Apollo Knit Wear (BD) Ltd.

ACCORD
on Fire and Building Safety in Bangladesh

Identified Priority 1 Concerns

As-built Structural Drawing

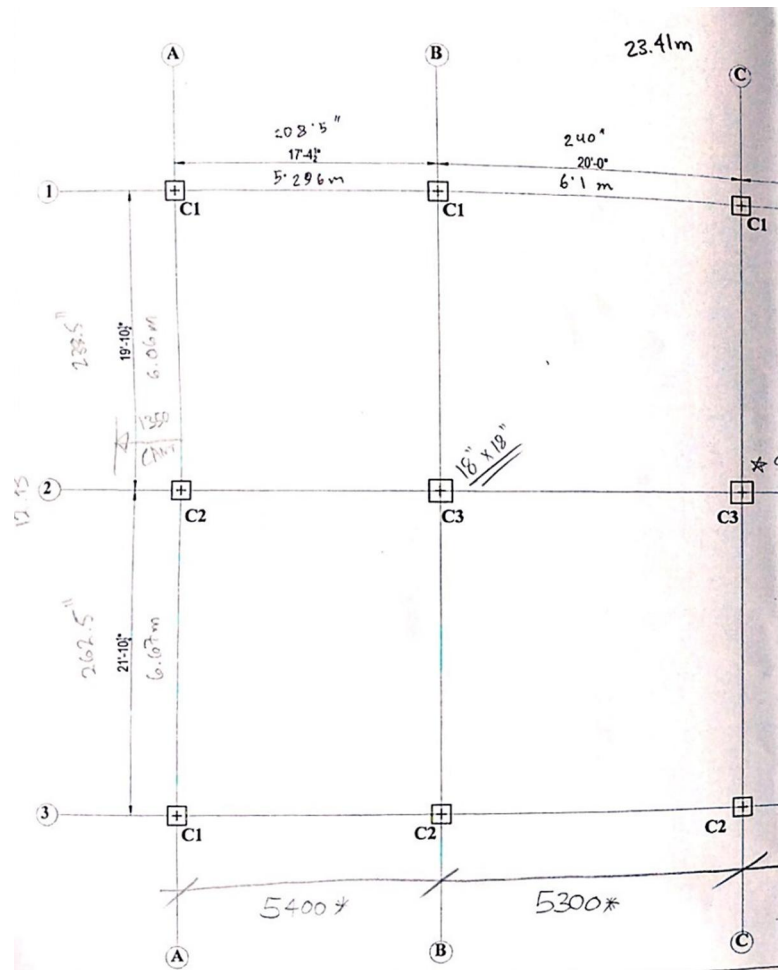
The structural as-built drawings provided to us did not match the site conditions and the actual building dimensions, such as:

- Different grid dimensions.
- Cantilevered floor slabs not shown on drawings.
- Brick aggregate used for construction instead of stone aggregate as noted on drawings.

Priority 1 Concern

- Update structural drawings to suit actual site conditions.

- Carry out a DEA as noted in the Item 2 actions; concentrating on dimensional differences, a lack of any recognisable lateral support system and the use of a different concrete aggregate.

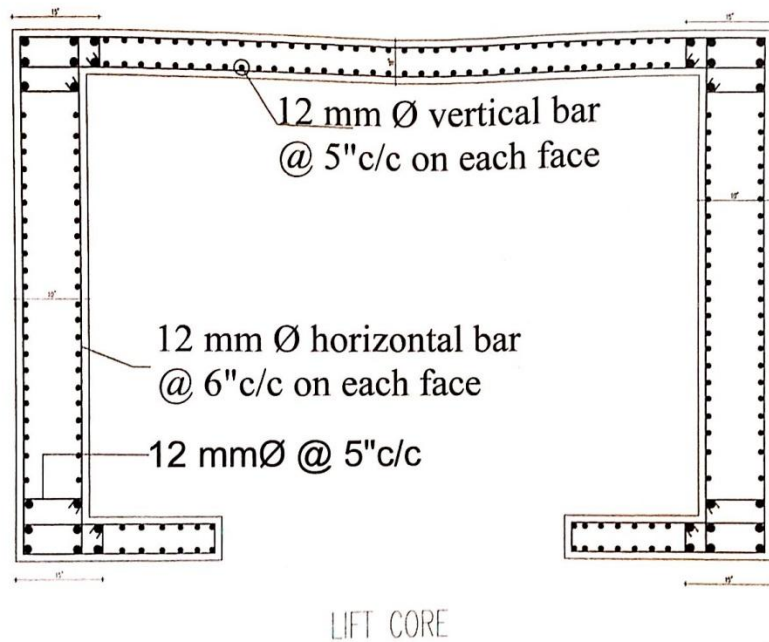
Priority 2 Concern

Rolls of yarn observed stockpiled over cantilevered portion of 4th floor slab at South wall (shown above) and West wall. Additionally, the cantilevered slab is not shown on the as-built structural drawings.

- Carry out a Detailed Engineering Assessment on the cantilevered portion of slab

- Display and enforce loading plans
